ADDRESSEES	: ABC Customer Care and Parts Source Owners and operators of coaches listed under 'Application'
VEHICLE MODEL	: CX., TX., TDX25
SYSTEM/SUBSYSTEM	: 6.10 Transmission – Control system
BULLETIN TYPE	: Field Change Program
DATE	: February 18th, 2020
SUBJECT	: Transmission refuses to shift into gear after a low air pressure condition
TERMS & CONDITIONS	: Refer to the warranty section further in this Bulletin

It has come to the attention of Van Hool that on the above mentioned vehicles the transmission sometimes refuses to shift into gear after a low air pressure condition.

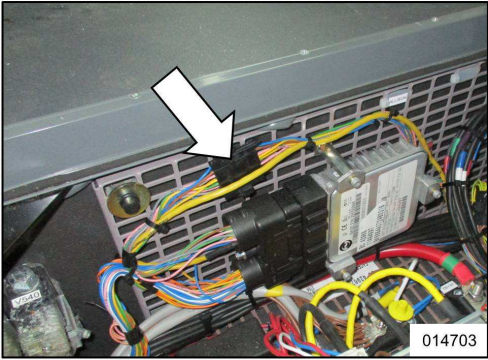
Step	Action
<p>1</p>	<p>Locate the 14-pin connector near the transmission control unit (TCM).</p>  <p>Figure 1: Location of TCM on TDX25</p>
<p>2</p>	<p>Cut the blue wire connected to terminal 14 at approximately 10 cm from the 14-pin connector. Isolate both wire ends with a heat shrink tubing.</p>  <p>Figure 2</p>
<p>3</p>	<p>Notify ABC Companies by mail. Write the text “SB1508 executed for VIN.....” in the mail and send the mail to warranty@abc-companies.com.</p>
<p>4</p>	<p>For ABC Companies only: register through the registration button located behind the Service Bulletin on the Van Hool customer portal. Write the text "SB1508 executed" in the field "Remark". Labor allowance will only be awarded after Van Hool has received the registration.</p>
